ORDER OF CONDITIONAL
APPROVAL OF FINAL PLAT

ORDER OF CONDITIONAL APPROVAL OF FINAL PLAT
FOR BRUNDAGE ESTATES SUBDIVISION NO. 2 FP-2025-0023

STAFF REPORT

SUBJECT: Brundage Estates Subdivision No. 2
FP-2025-0023

JOB NO. 24-36
SHEET 2 OF 4

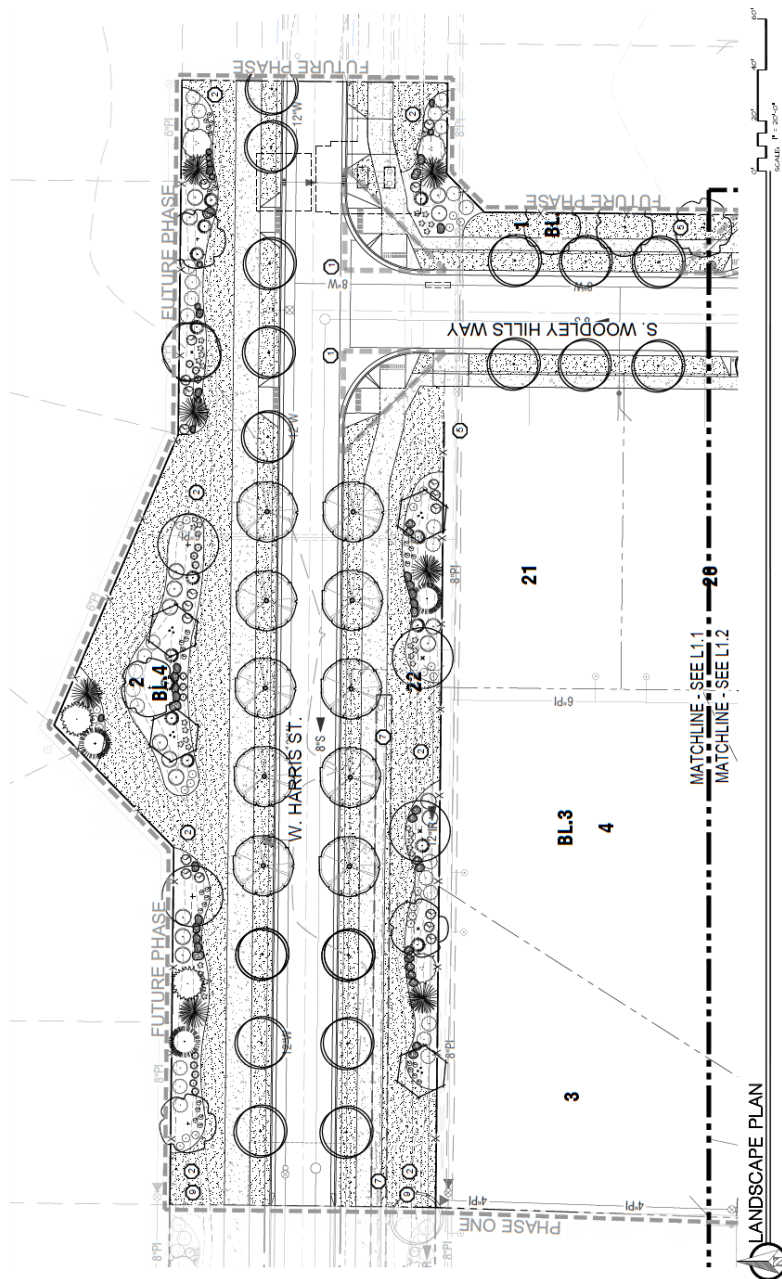
3. Prior to submittal for the City Engineer's signature, the Certificate of Owners and the accompanying acknowledgement signed and notarized.
4. The final plat shown in Section V.B prepared by Engineering Solutions, stamped on 9/7/2025 by Clinton W. Hansen, shall be revised as follows:

- a. Note #11: "A portion of Lot 22 of Block 2 ~~are~~is servient to and contains the Ada County Highway District storm water drainage system. ~~These lots are~~This lot is encumbered by . . ."

- b. Graphically depict the portion of Lot 22, Block 2 covered by the storm water drainage system easement described in Note #11.
 - c. Note #12: Include the recorded instrument number of the ACHD temporary license agreement.

- d. Note #13: Include the recorded instrument number of the CC&R's.
 - e. Note #15: Include the recorded instrument number of the ACHD development agreement.

A revised plat shall be submitted with the final plat signature application.
5. The landscape plan shown in Section V.C, dated 8/7/2025, shall be revised as follows:
 - a. Include additional landscaping along the pathway on Lot 20, Block 2 and Lot 10, Block 3 in accord with the standards listed in UDC 11-3B-12C.
 - b. The fencing type along the rear lot lines of Lots 20 and 21, Block 1 adjacent to the common lot (i.e. Lot 19, Block 1) where the Calkins Lateral has been piped shall be changed to an open vision or semiprivate fence up to six (6) feet in height or four (4) feet in height if closed vision fencing is used [an additional two (2) feet in height of open vision fencing may be provided to the top section of the fence], per UDC 11-3A-7A.7b.
